Initial Comments on 6 GHz KDB Guidance

Submitted by Broadcom Inc., Hewlett Packard Enterprise, Intel Corp., and Qualcomm Inc.

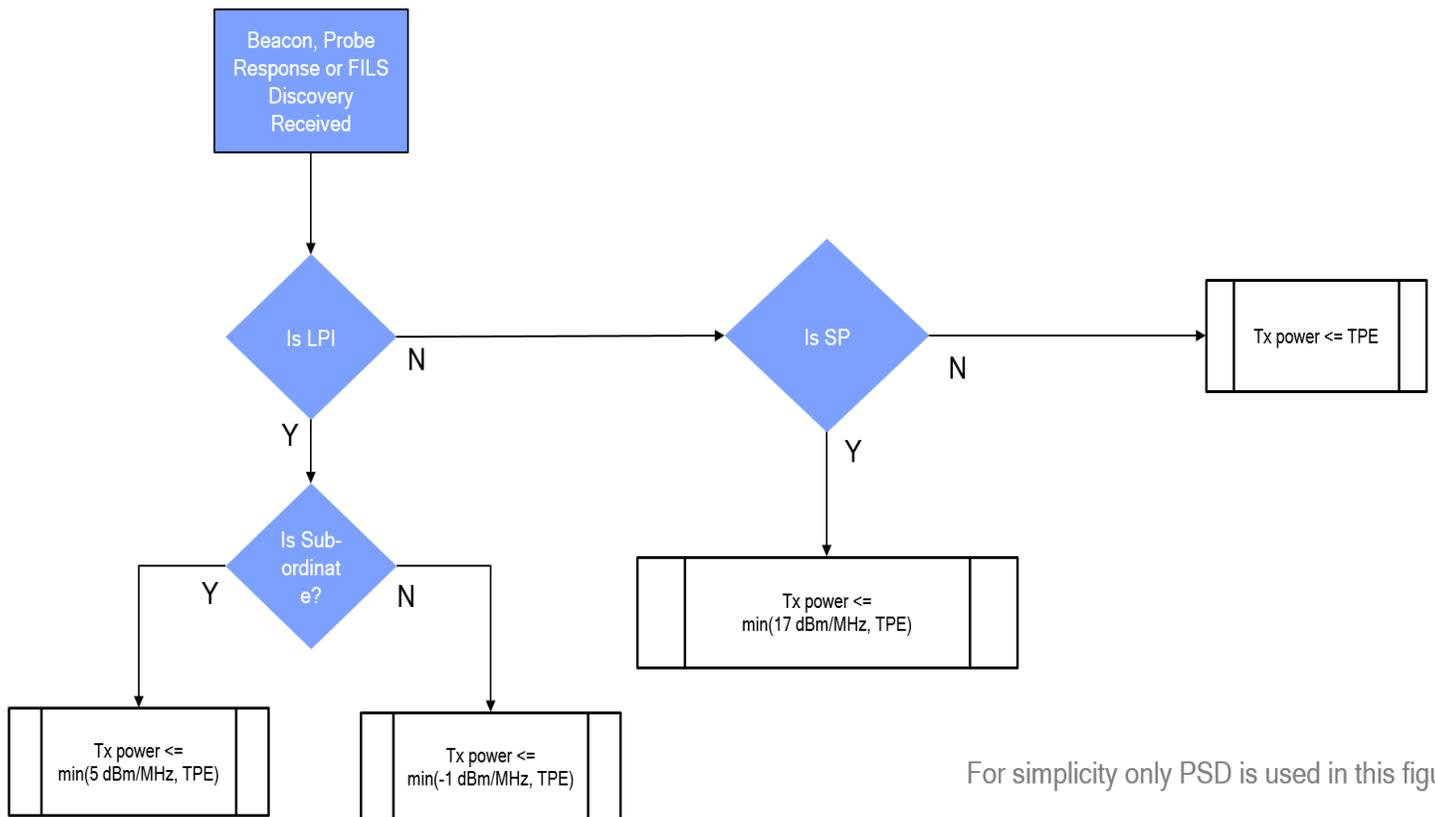
We respectfully request that the FCC accept an applicant’s written declaration of how a client device will ensure its power level does not exceed the applicable regulatory limit, such as by using TPE defined in the IEEE 802.11 standard and its amendments or a similar mechanism available in 5G NR-U. This proposal provides important forward compatibility for client devices by allowing them to associate with existing and future AP categories¹ while ensuring a client’s transmit power remains below allowable levels for the clients of each AP category. This proposal also would simplify the client device certification process.

The following flow diagram shows how client devices could determine their allowed transmit power based on the IEEE 802.11 protocol. For simplicity only PSD limits are used. Note that the IEEE 802.11 protocol also signals total power for different channel bandwidths.
